Addendum

Series ezPAC™ for SA310/SA320/SA330 R option devices

- Installation Manual – BG0325;
- Operational manual – BG0346.

Figure 1: Dual Ethernet Port ezPAC top view.

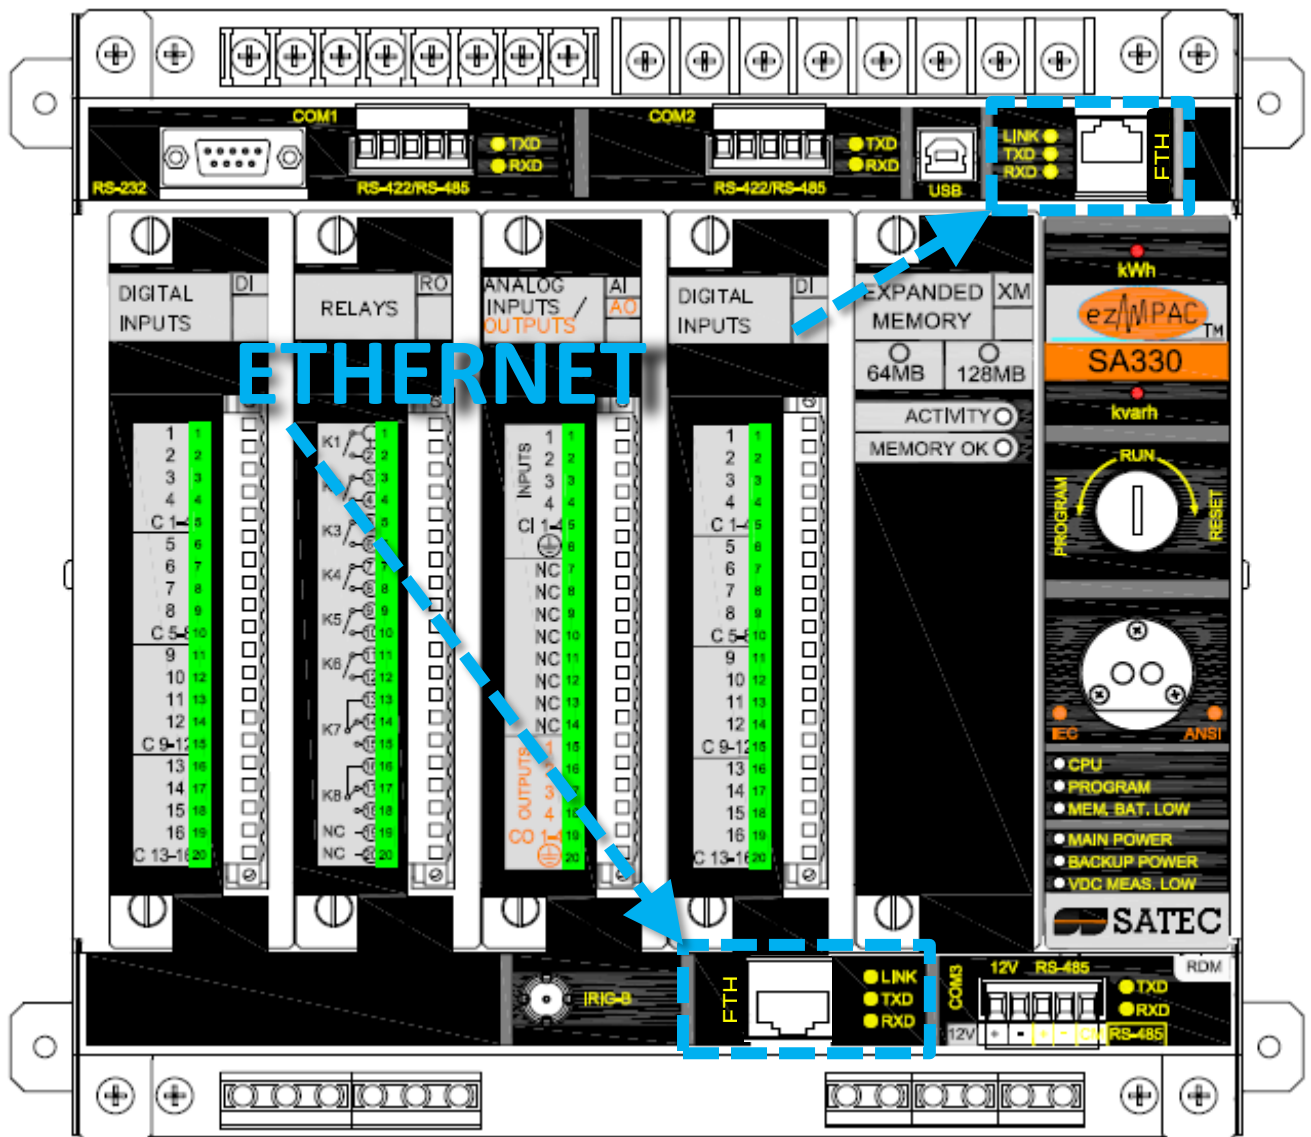
This SA3xx series option provides two Ethernet Communication ports: PORT-A & PORT-B, see the figure below.

The dual ETHERNET ports SA3xx option cannot support the internal Embedded 56K dial up modem.

The additional ETHERNET port (B) provides 10/100Base T redundancy line.

Both ports, A and B, are connected to 10/100Base lines, while only one of them is active.

If the active line is damaged or disconnected or not available for at least 10 seconds, the IED SA3xx0 series will switch automatically to the other port, followed by LEDs port indications.
